APEX MAIN EMS STATION

6950 APEX BARBECUE ROAD, APEX, NORTH CAROLINA 27502 | WAKE COUNTY REQUEST FOR BIDS NUMBER: RFB-23-080

ADDENDUM NO. 1

DATE: OCTOBER 17, 2023

COVER SHEET

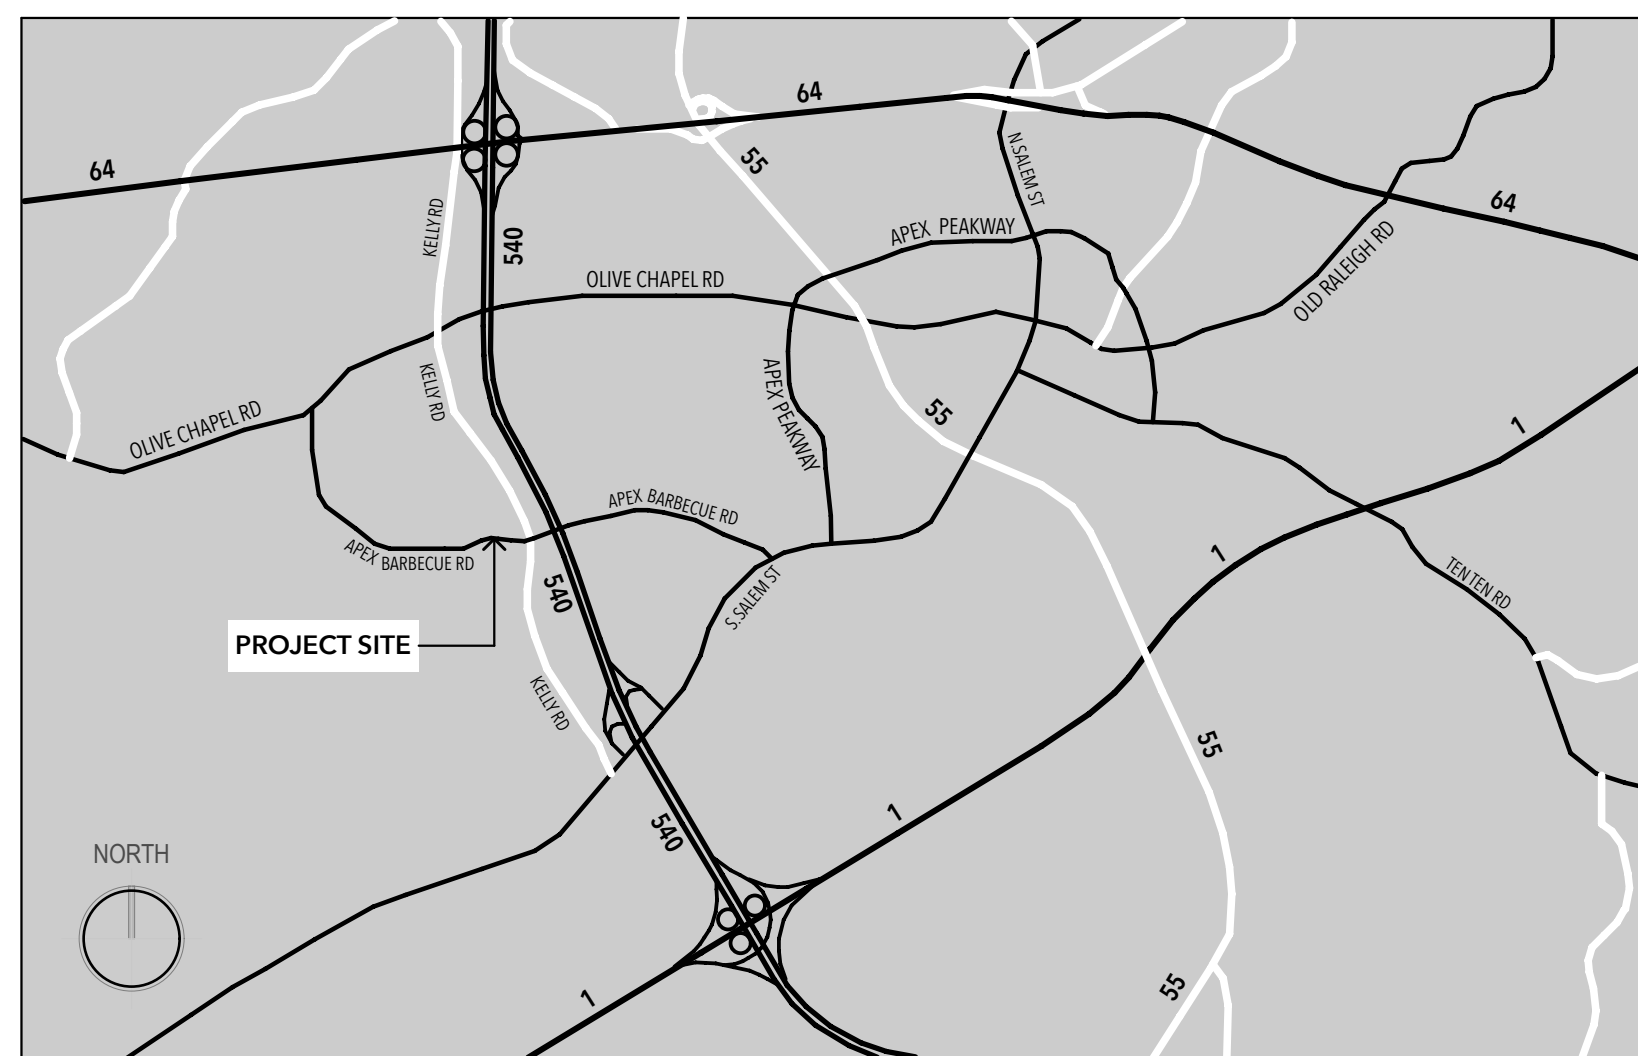
1. **REPLACE** Sheet G101 – Cover Sheet with the attached, updated G101 – Cover Sheet (Revision 2, Dated 10/11/23). Drawing Sheet S002 – Statement of Special Inspections added to the Drawing Index. Owner contact information updated.

SHEET:
G103

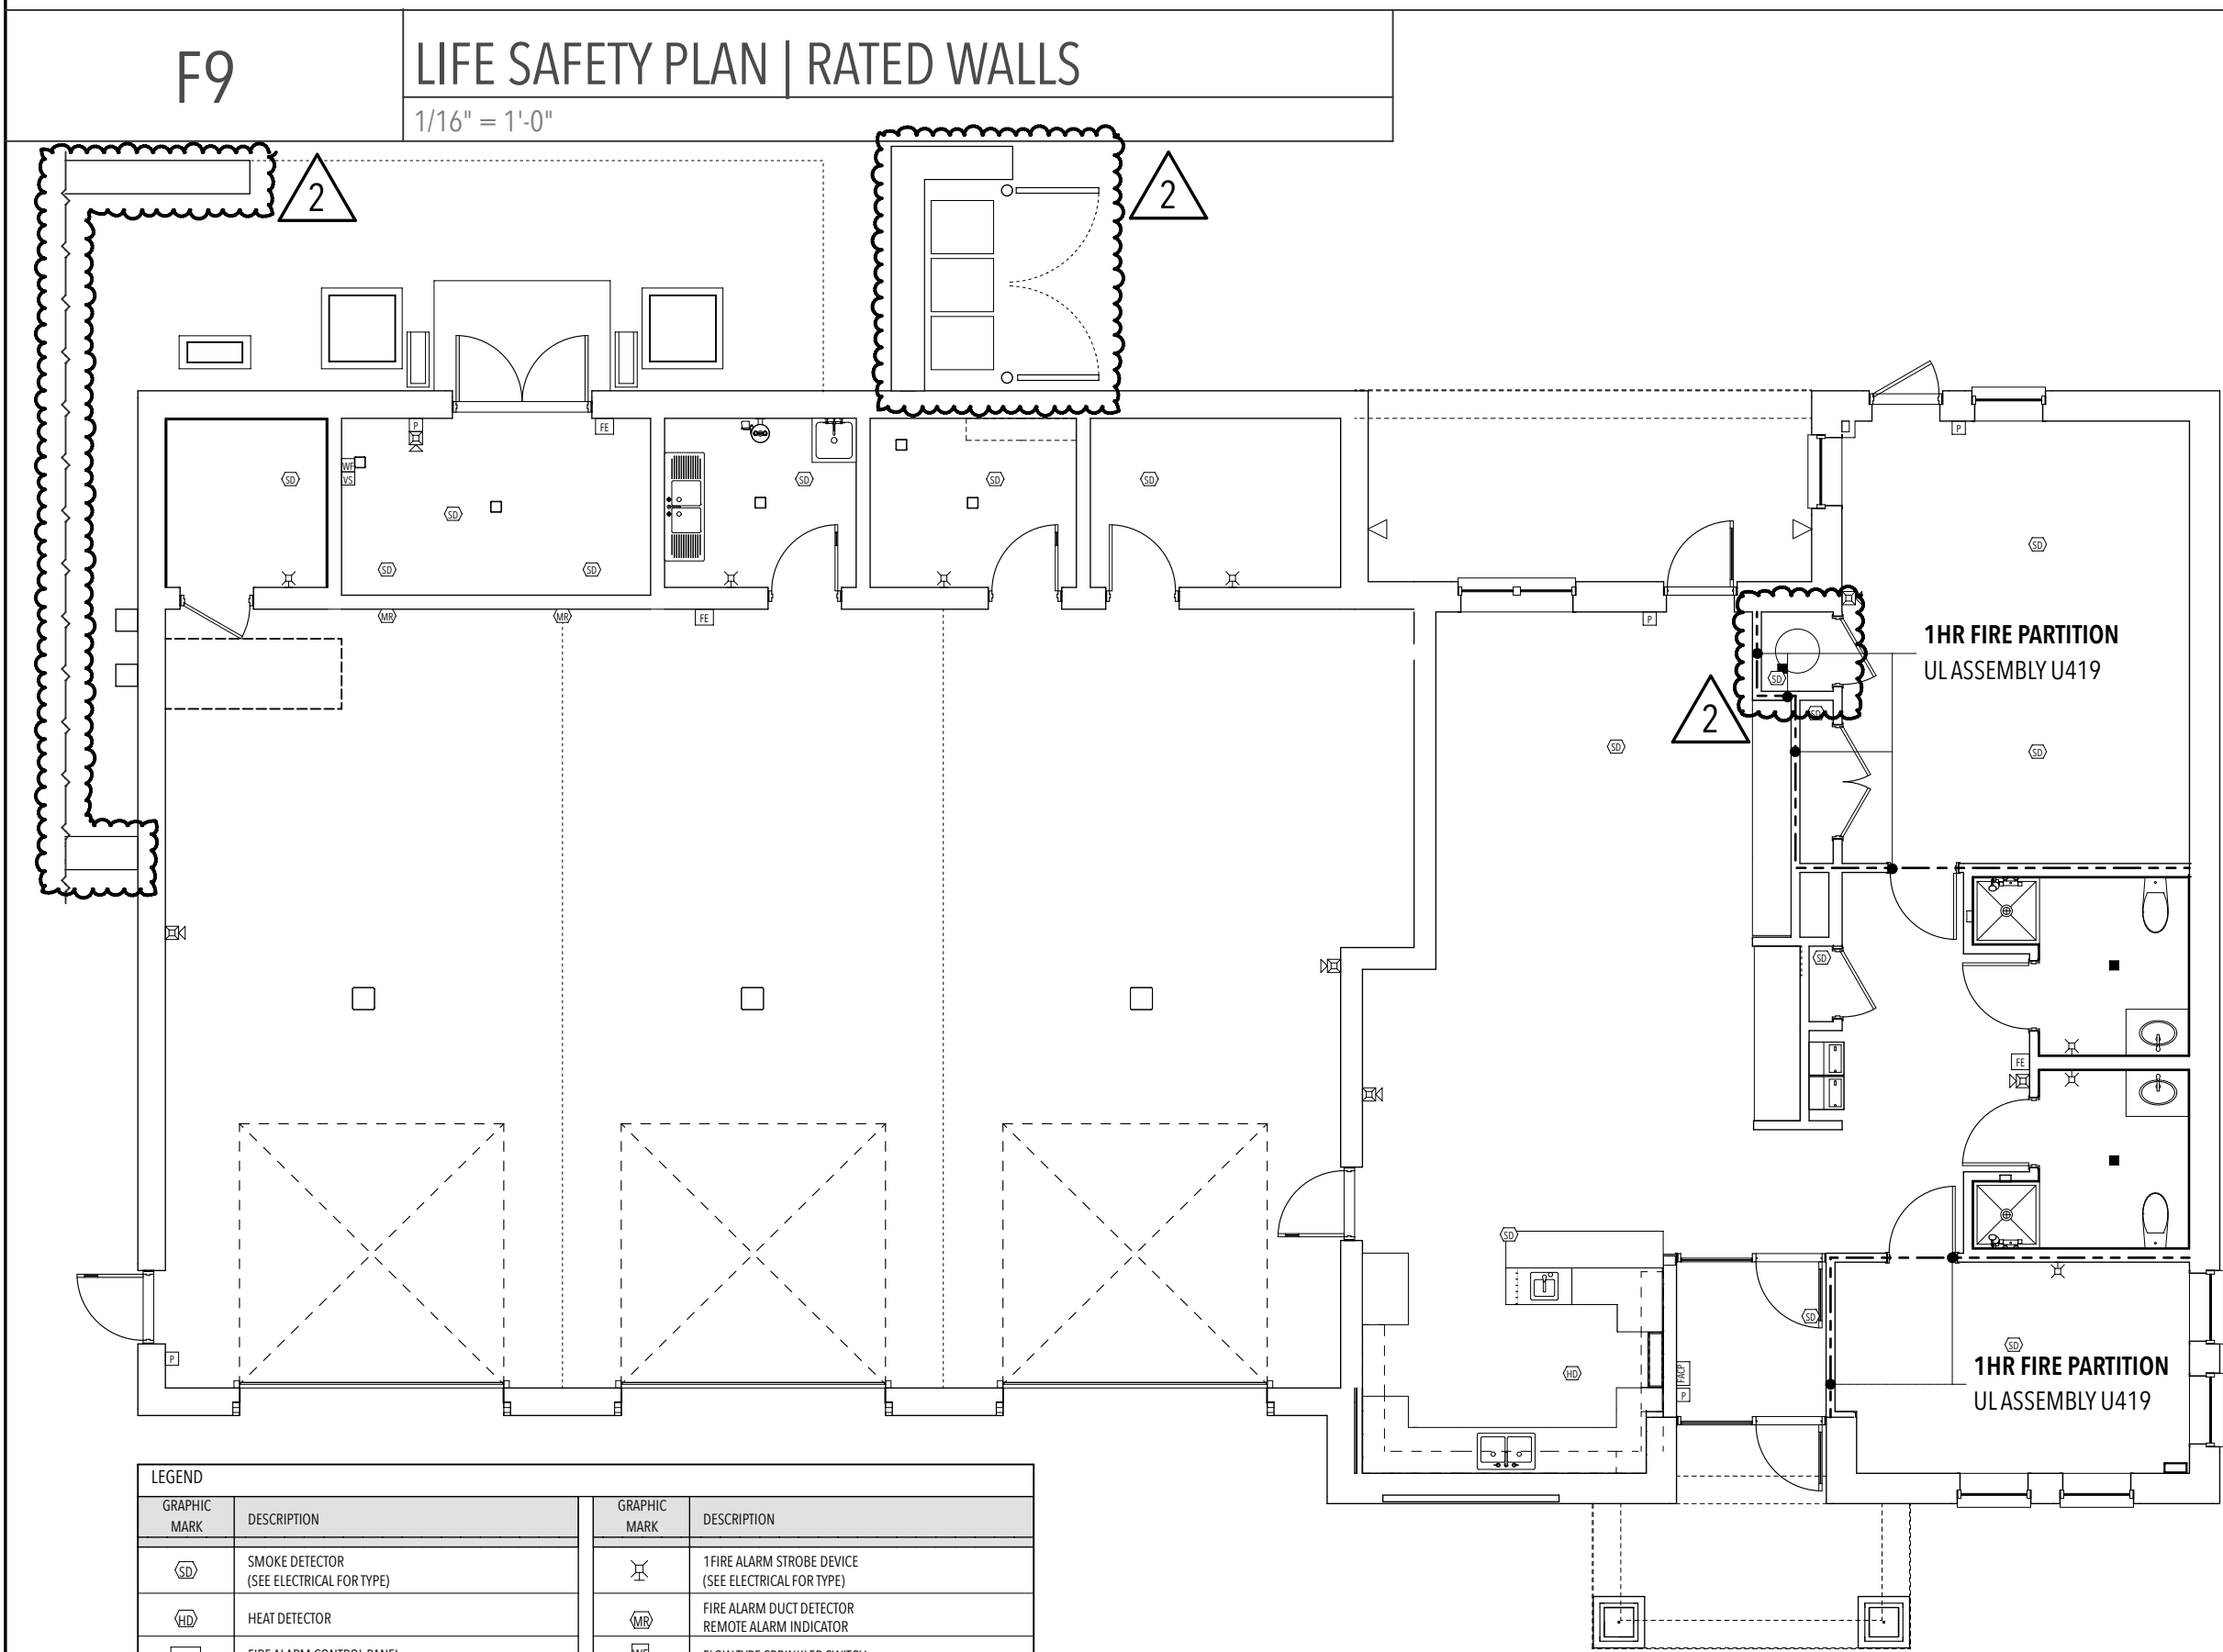
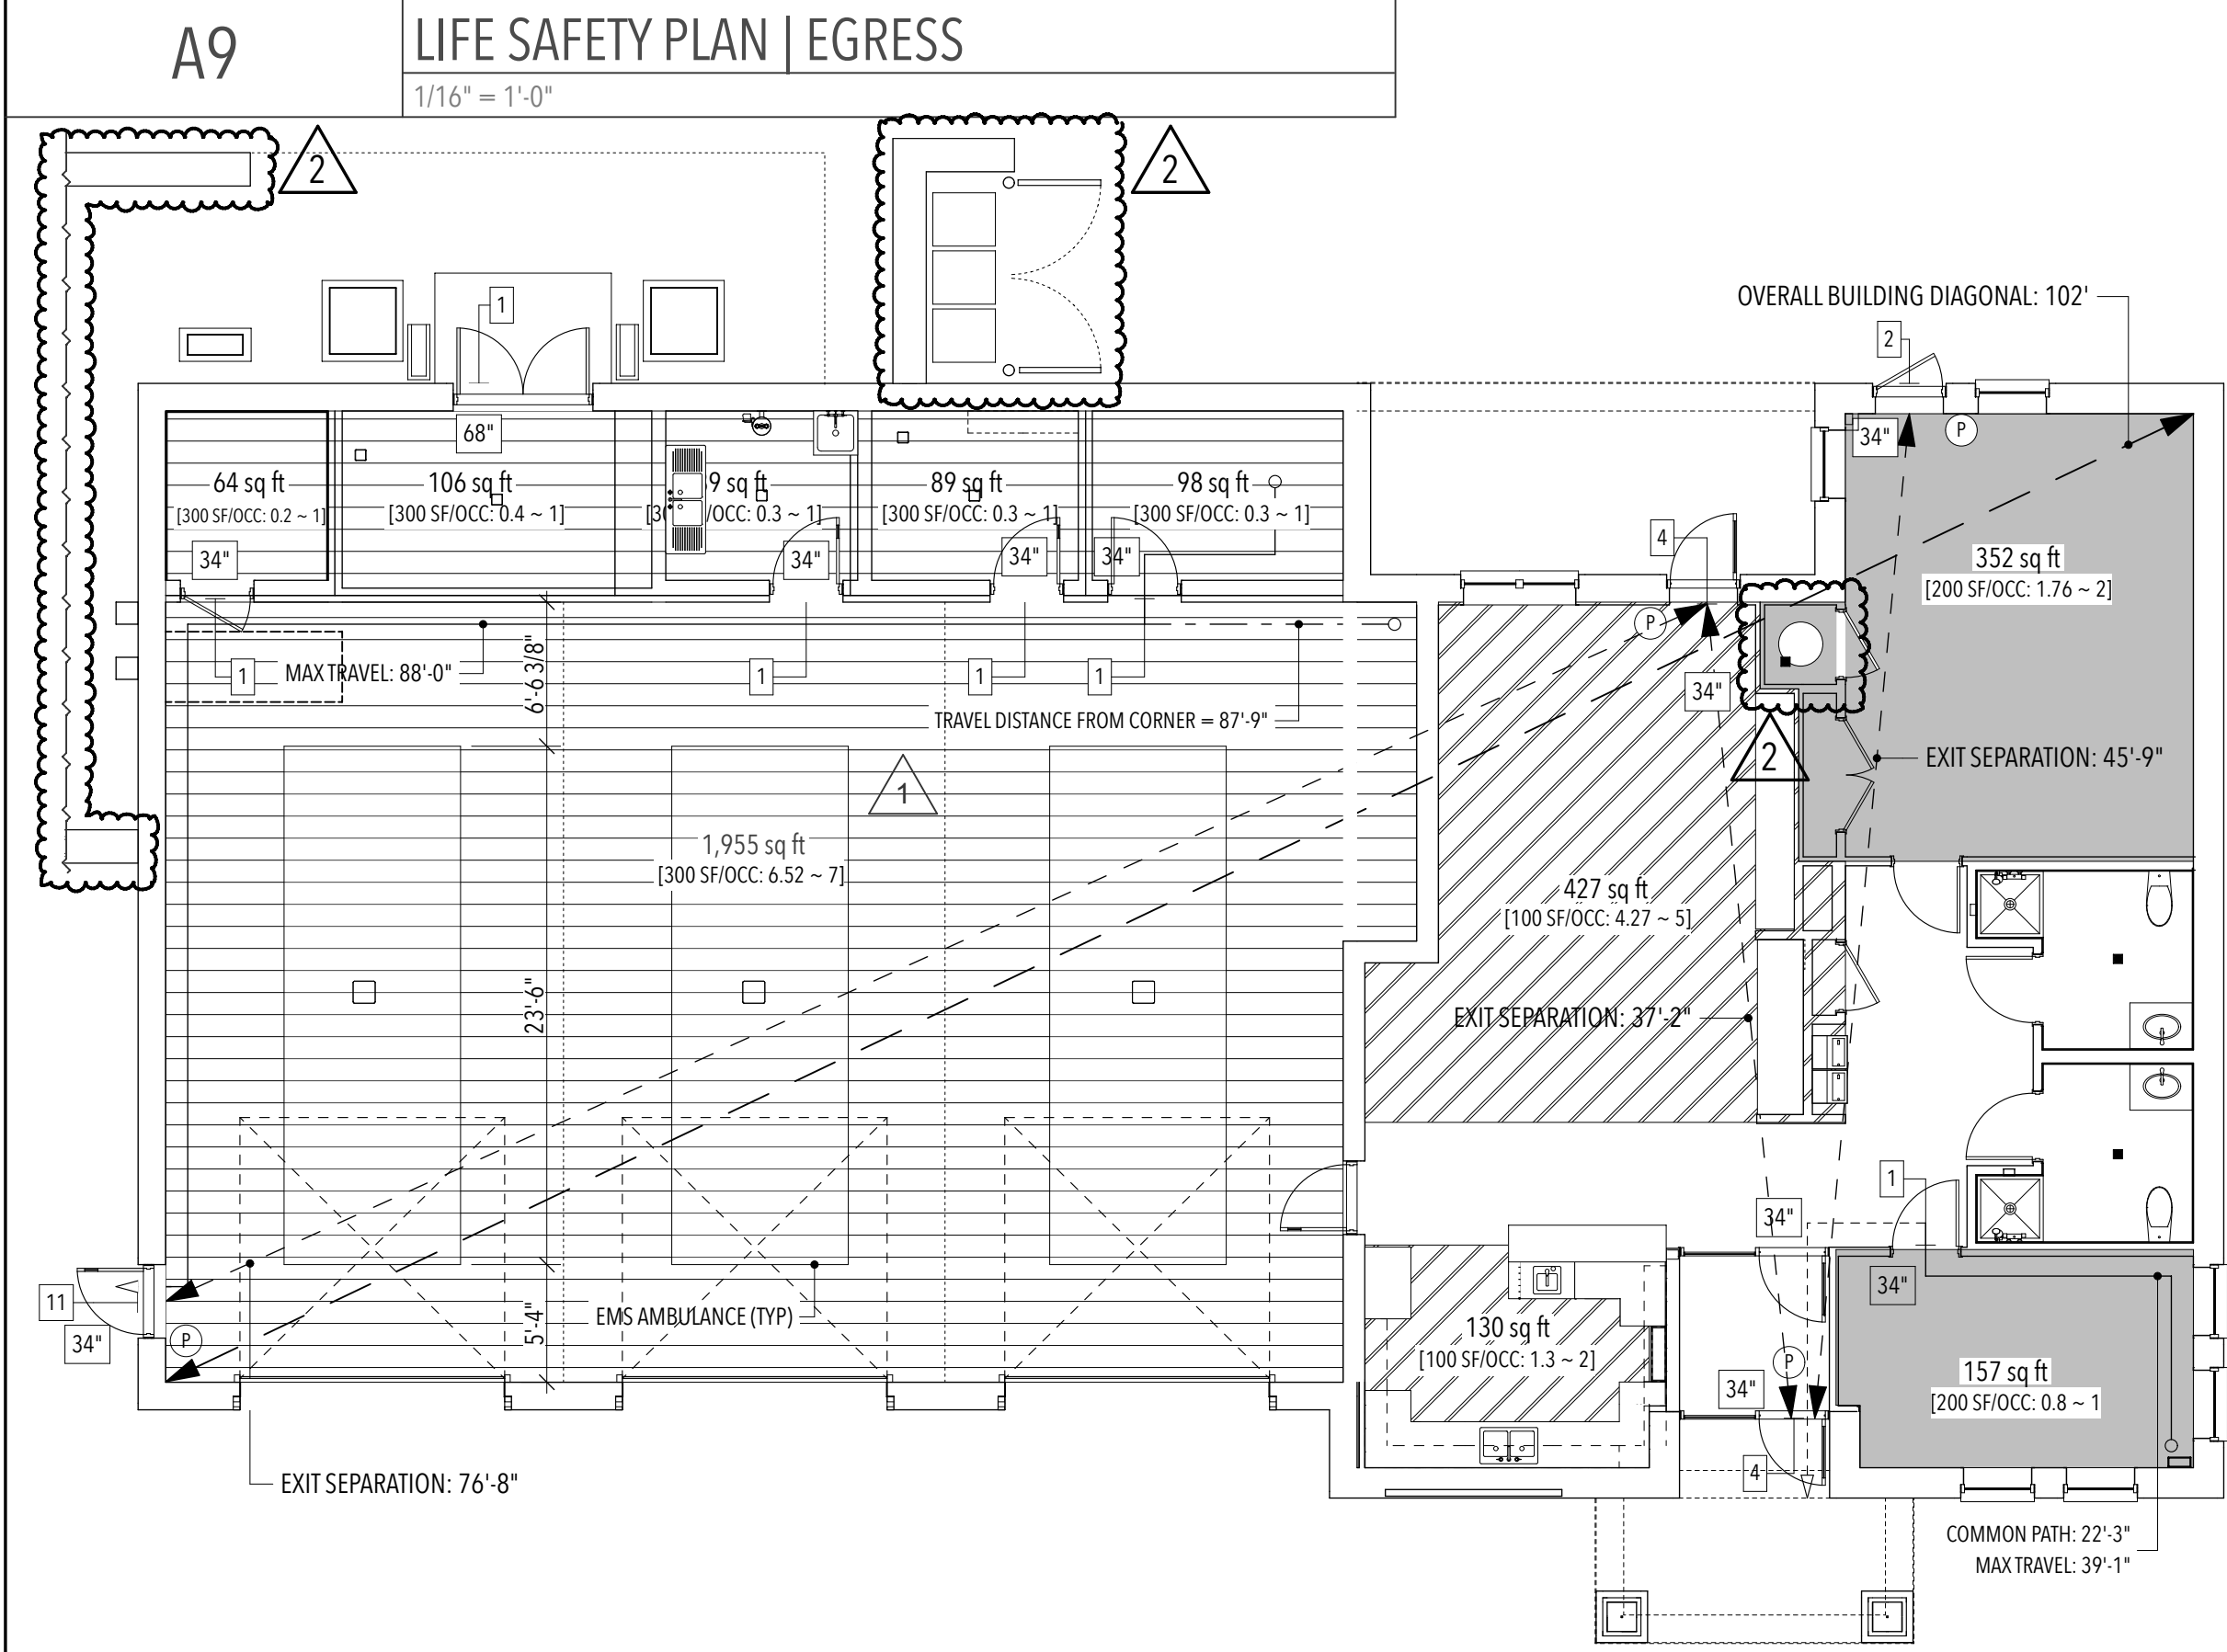
1. **REPLACE** Sheet G103 – Code Summary with the attached, updated G103 – Code Summary (Revision 2, Dated 10/11/23). Detail A9/G103 – Life Safety Plan | Egress and Detail F9/G103 – Life Safety Plan | Rated Walls base plans updated.
